CITY OF ALBUQUERQUE

January 30, 2023

**RE: Take 5 Oil Change
10415 Central Ave NE
Grading and Drainage Plans
Engineer's Stamp Date: No Date
Hydrology File: L21D059B**

Based upon the information provided in your submittal received 01/30/2023, the Grading & Drainage Plans **are not** approved for Building Permit, Grading Permit, and SO-19 Permit. The following comments need to be addressed for approval of the above referenced project:

DESIGN REVIEW COMMITTEE	CITY ENGINEER APPROVAL	ZONE MAP NO. Z-99
		CITY PROJECT NO. 000000
		SHEET NO. C4.0

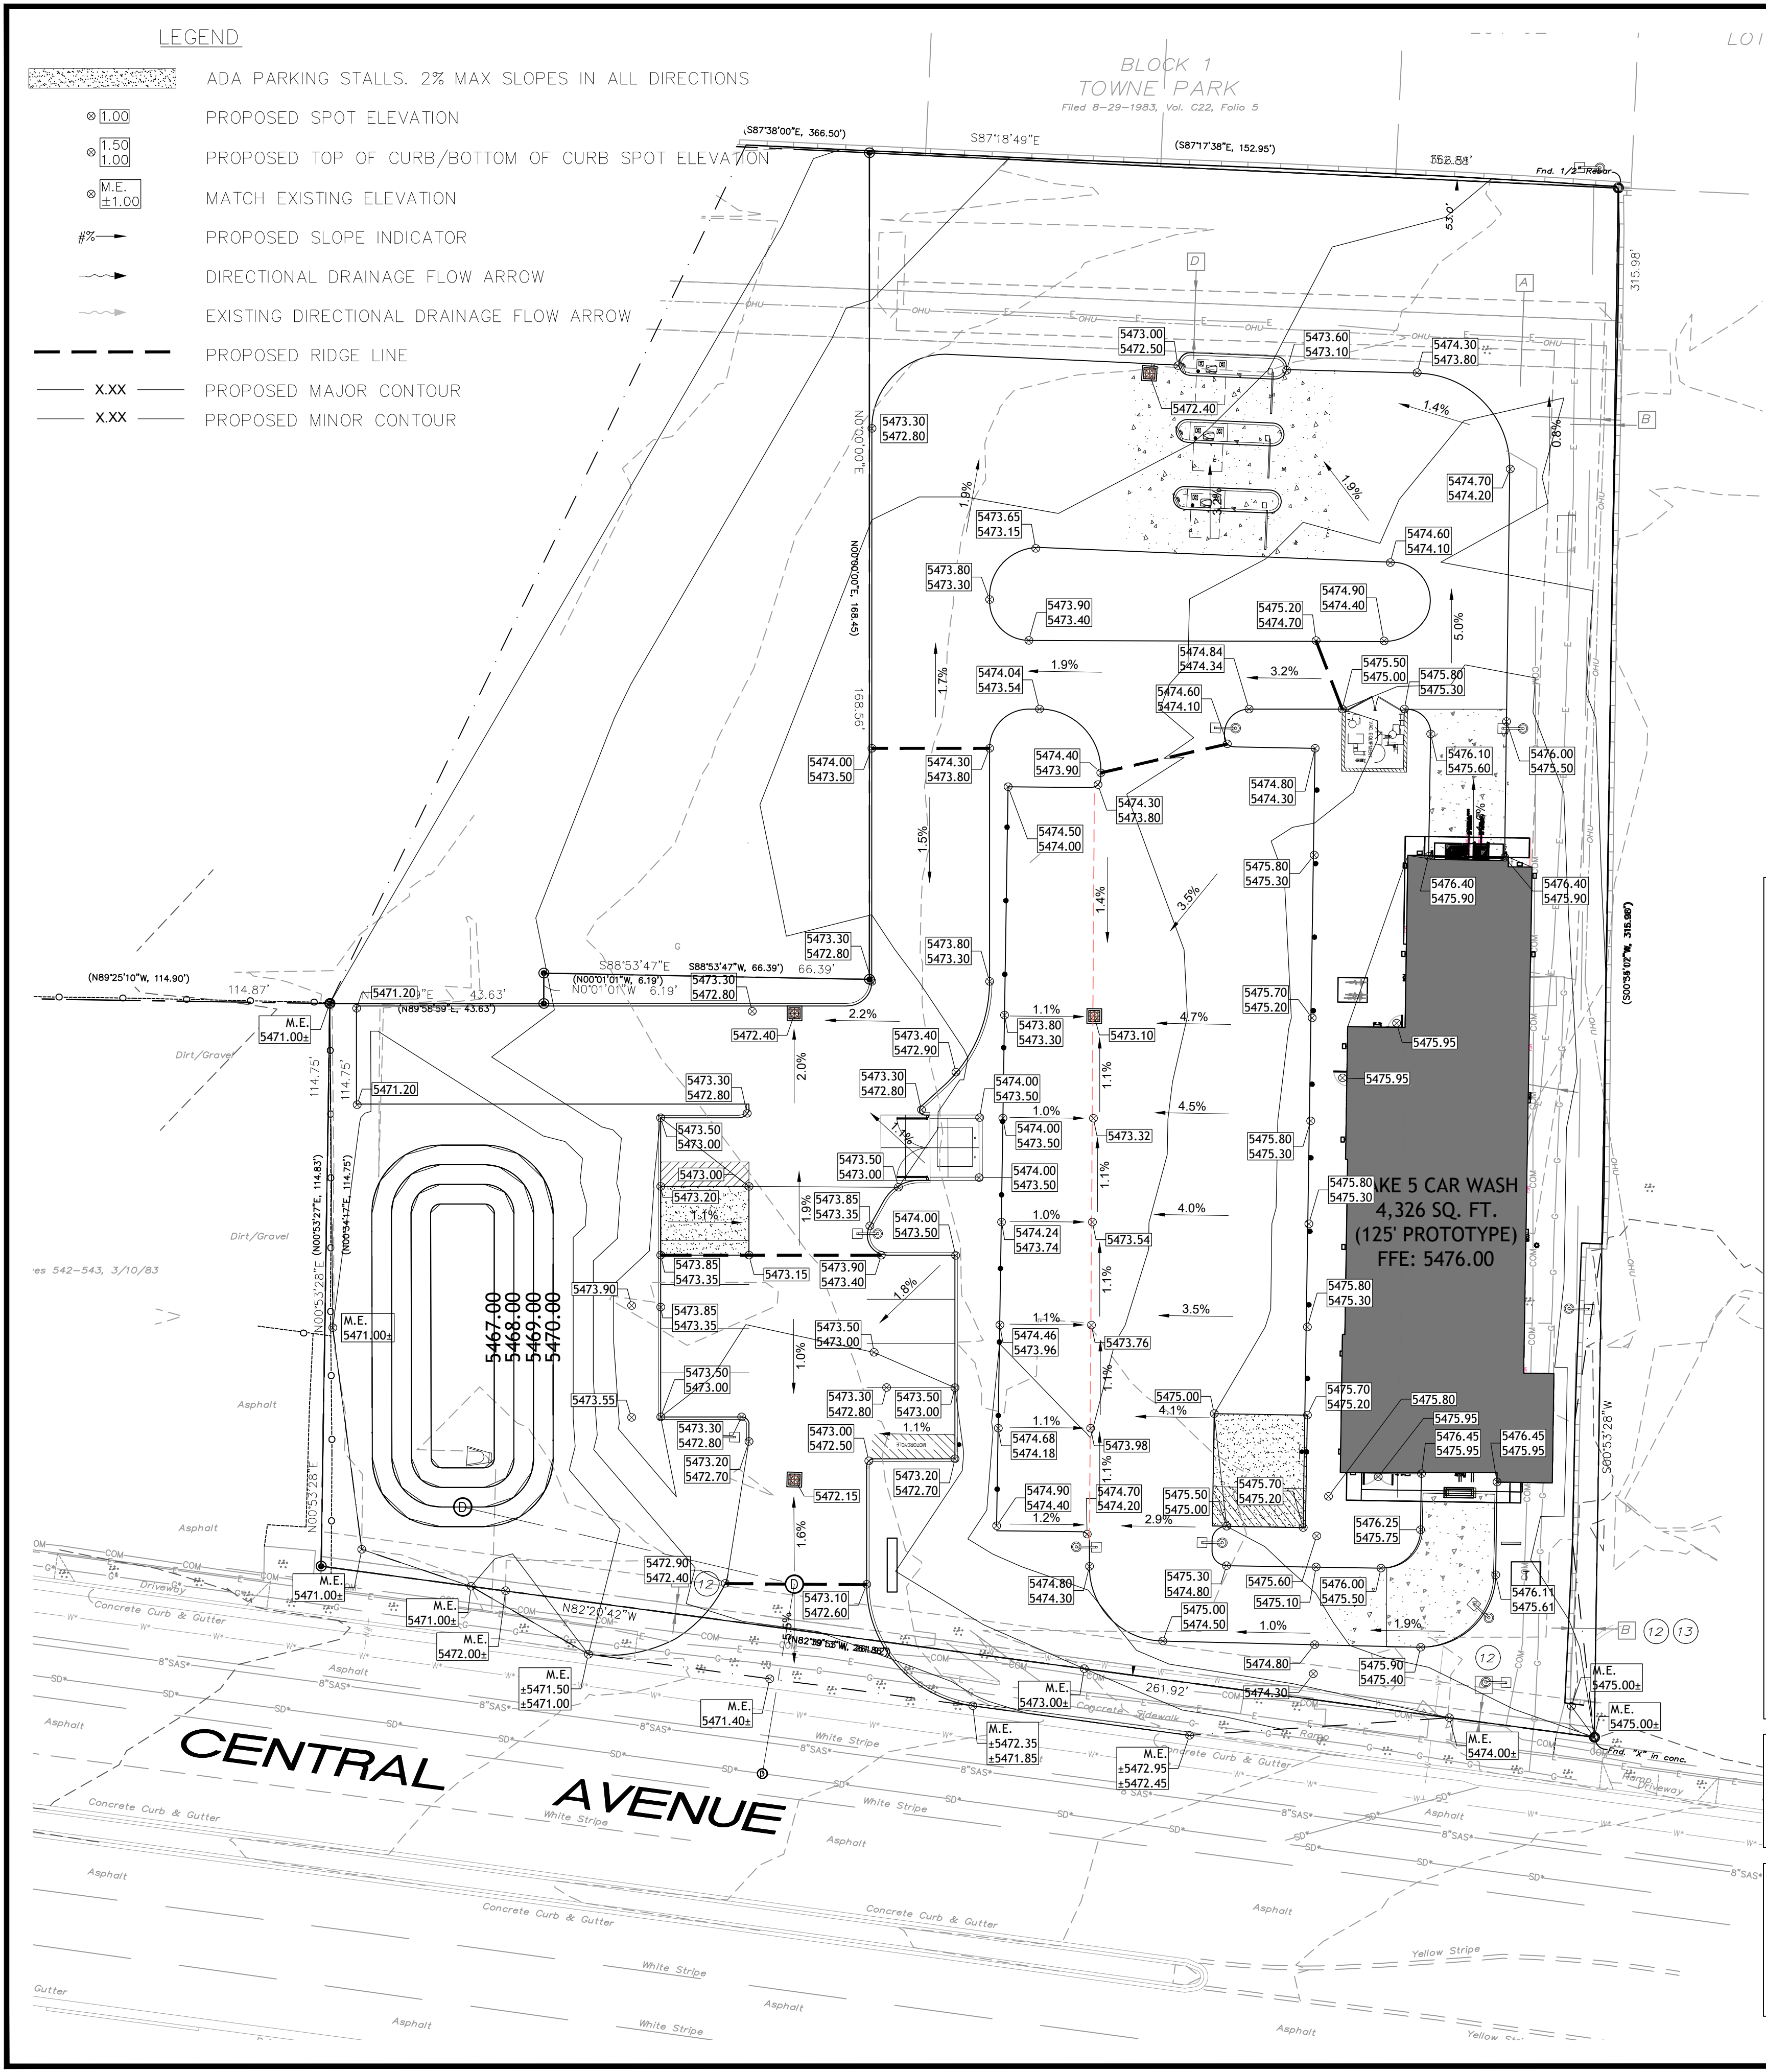
2. Per the DPM, the following must be on the Grading Plan. Please note the Grading Plan must be a stand-alone construction document.
 - a. Please provide an engineer's stamp **with a signature and date**.

- b. Please provide a Vicinity Map. Typically, this is the Zone Atlas. This can be downloaded in pdf format from the City of Albuquerque's website.
 - c. Please provide the Benchmark information (location, description and elevation) for the survey contour information provided. This is a City Benchmark that the surveyor should have pulled from.

- d. Please provide a legal Description of the property.
3. Work on the adjacent property is prohibited without written notarized consent from that property owner. According to the Demolition Plan, the work stops along the property line. Therefore, please show the existing asphalt on the adjacent property. It appears that proposed project of Murphy's never proceeded.

DRAINAGE PLAN

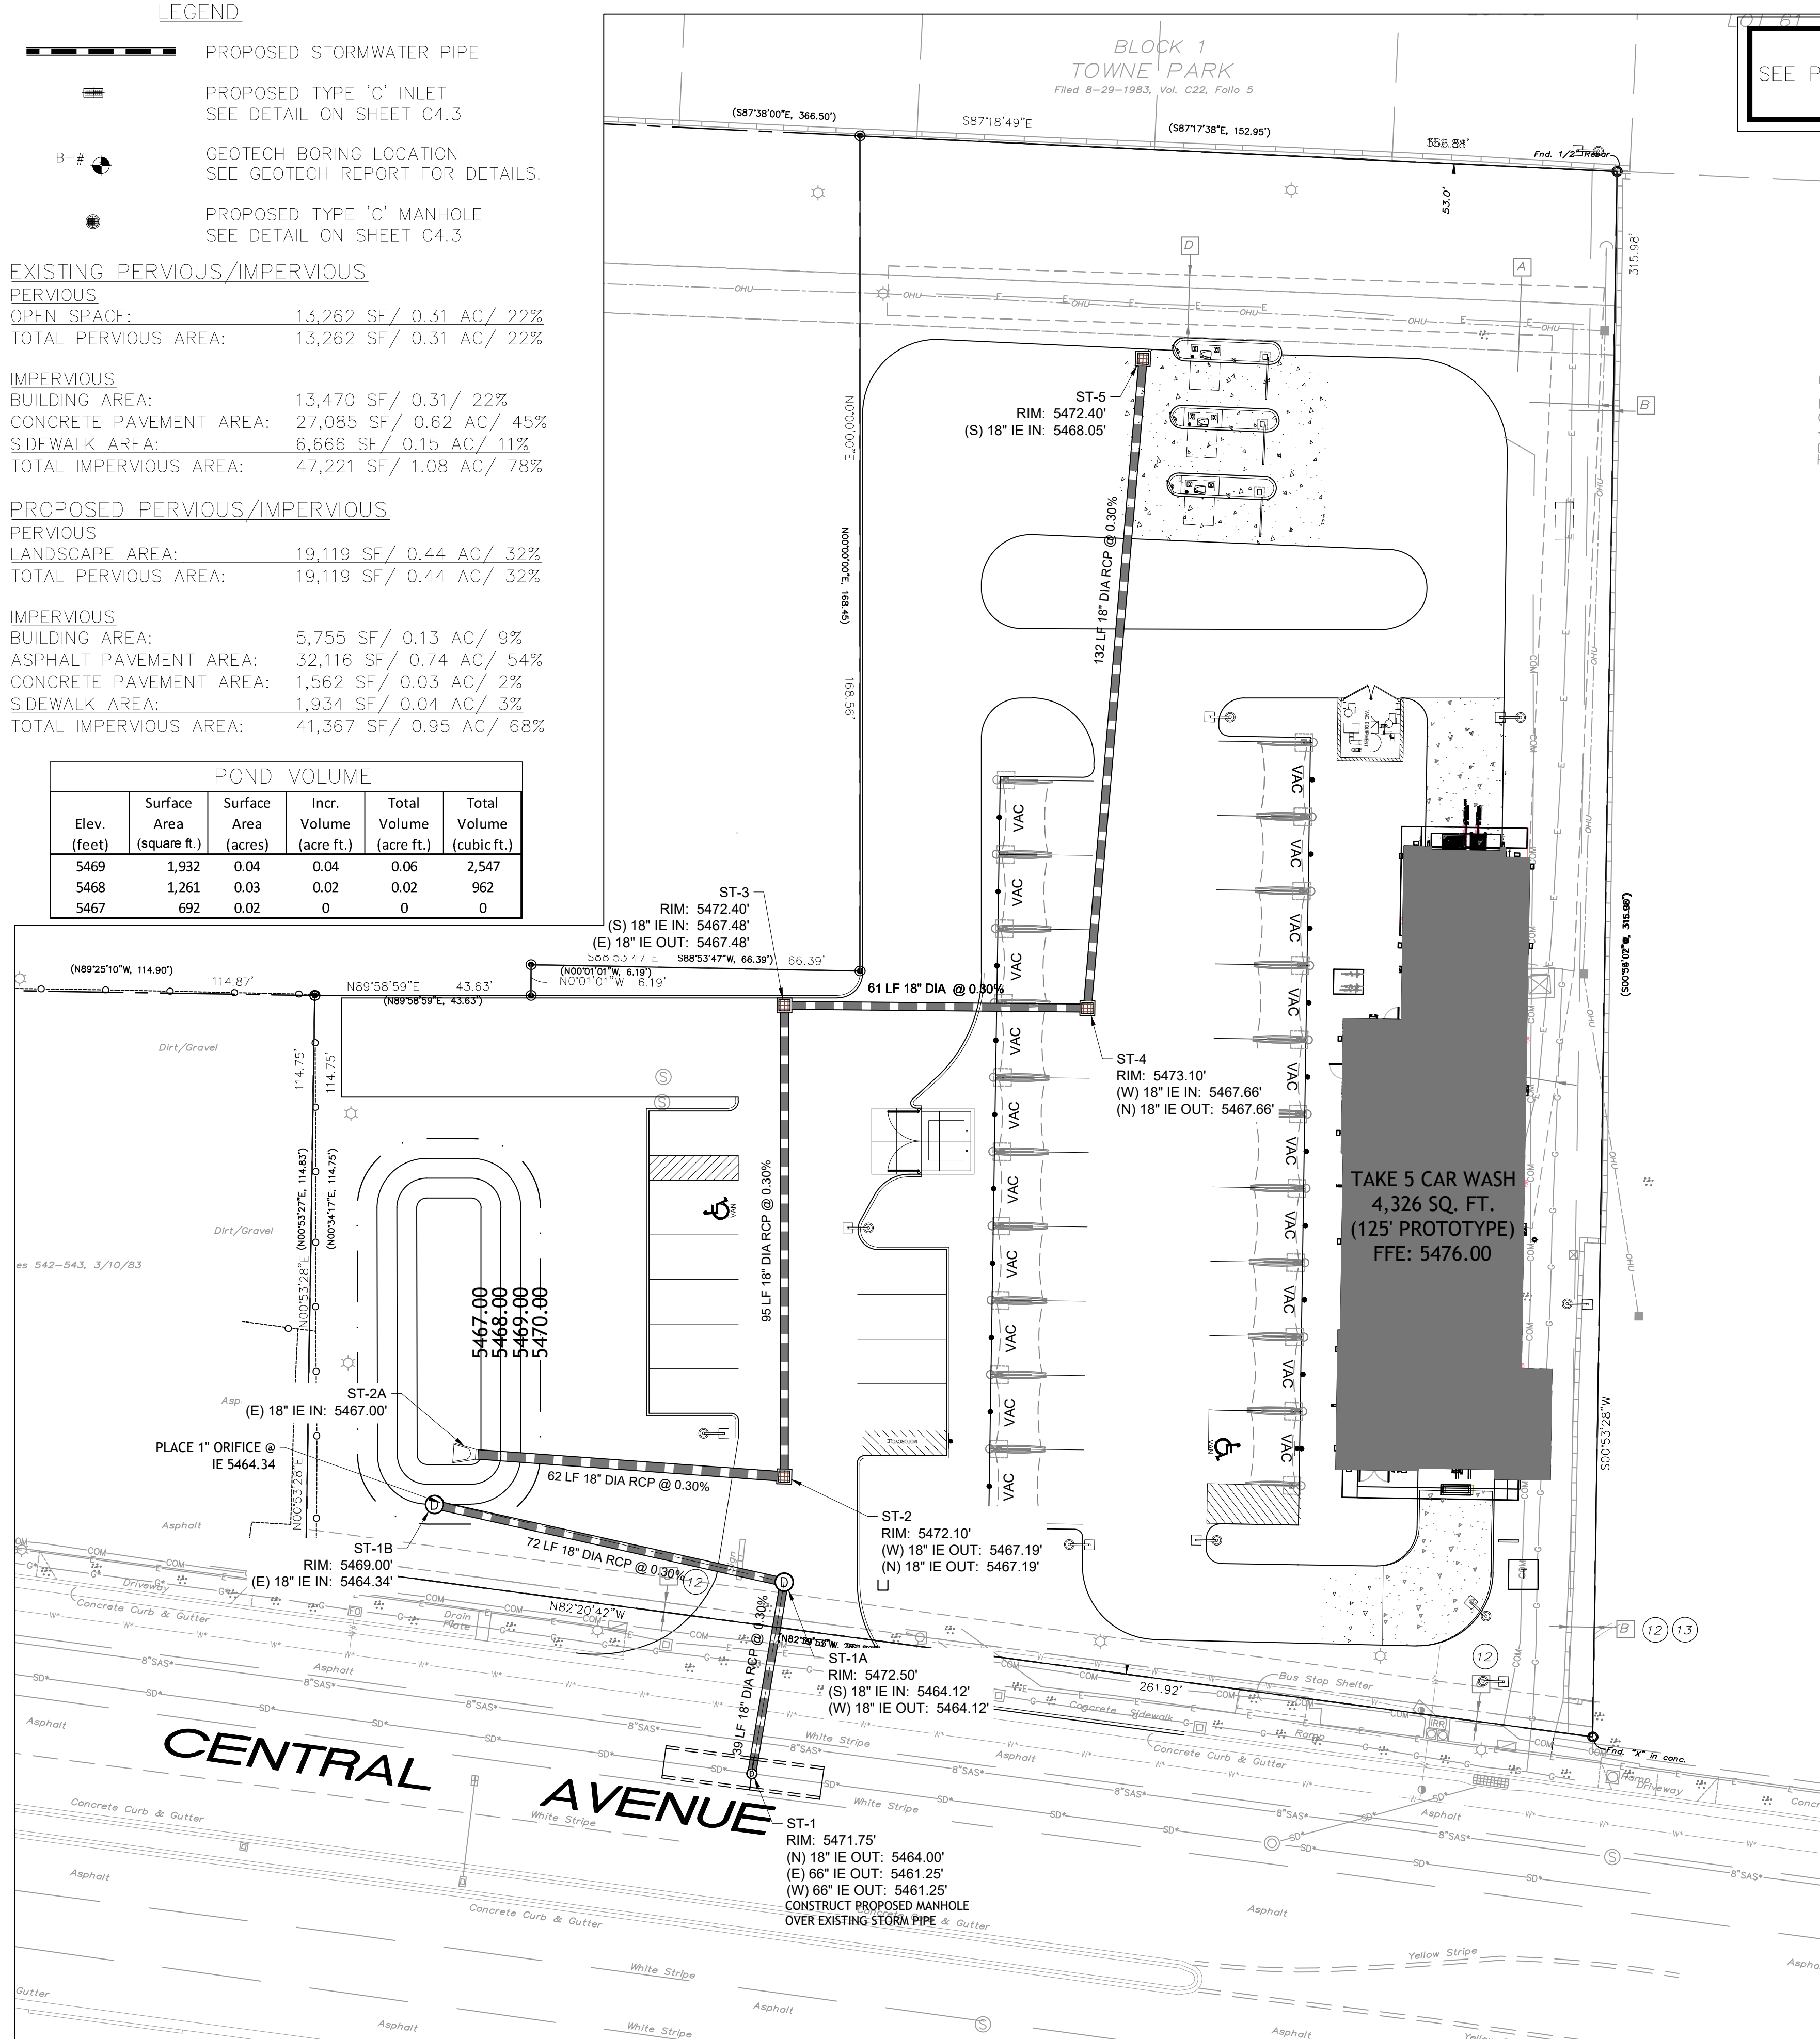
- Please provide a cross section for the stormwater quality pond showing the top of pond, bottom of pond and the SWQ required volume elevation. Please add a note, "Side slopes need to be stabilized with Native Grass Seed (per City Spec 1012) with Aggregate Mulch or equal (Must satisfy the "Final Stabilization criteria" CGP 2.2.14.b.)".

5. Please add the volume provided under the Stormwater Quality Calculations.
6. For the outfall of the SWQ pond, an outfall pipe connecting to the existing storm sewer system in Central is not needed. Instead, a two-foot or one-foot sidewalk culvert (depending on site's discharge) at the elevation of the required SWQ volume elevation at the pond and the existing flowline elevation at the curb is all that is needed. There is an existing sidewalk culvert for the existing site that may be utilized if in good condition.

7. So, if you use a new sidewalk culvert, please reference City of Albuquerque standard detail No. 2236 – Sidewalk Culvert with Steel Plate Top at the sidewalk culvert. Also, please provide the weir calculations, per DPM Article 6-16(A), for the curb cuts and sidewalk culverts. A coefficient of 2.7 is typically used for the weir equation $Q = CLH^{2/3}$.
8. A SO-19 Permit will be required for the sidewalk culvert. Please include the standard SO-19 notes (attached) on the grading plan.
9. Please use the procedure for 40 acre and smaller basins as outlined in Development Process Manual (DPM) Article 6-2(a). Please provide both the existing conditions and proposed conditions for the 100 year-6 hour storm event. These calculations should be on the Drainage Plan.
